# Axcelerator Family FPGAs Errata

Some errors were found in the Axcelerator data sheet. The corrections, noted below, will be incorporated into a revised version of the data sheet. The changes in the graphics are indicated in red font. Within the body, corrections are in bold.

**Page 16**

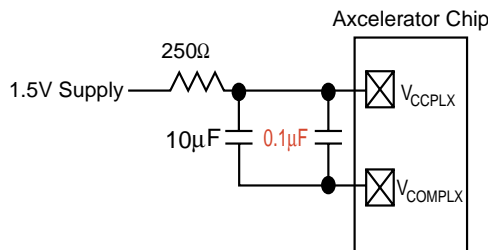
1. In the figure, the value for the capacitor on the right is incorrectly shown as 100 $\mu$ F. The correct value is **0.1 $\mu$ F**.

**Page 70**

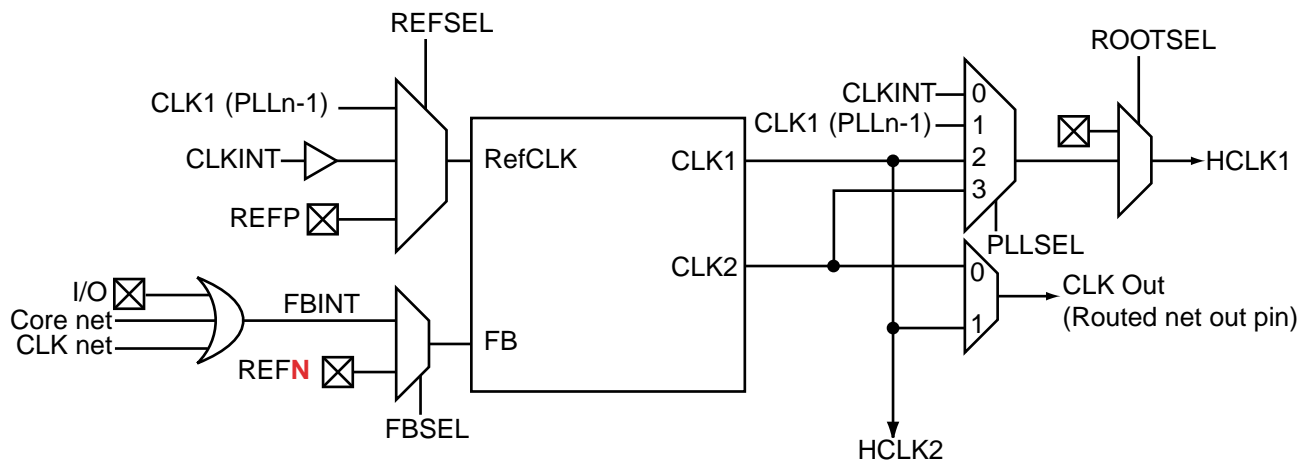
2. In the interface block diagram one of the signals is shown incorrectly as REFD. It should be **REFN**.

**Page 75**

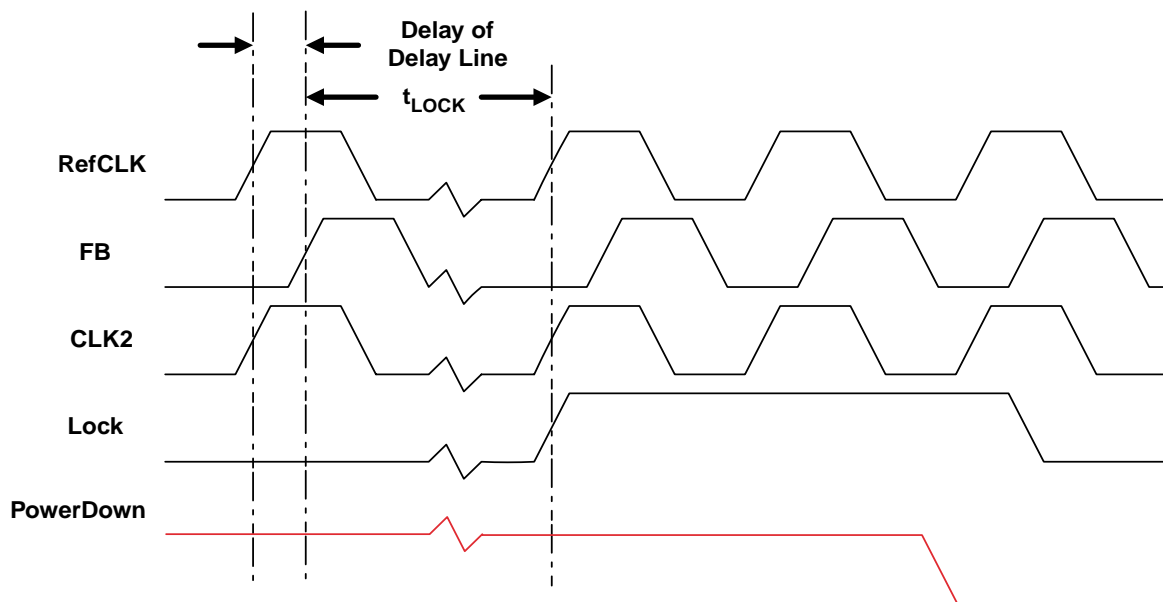
2. In the timing waveform diagram, the PowerDown signal is drawn incorrectly. The figure below shows how it should appear.
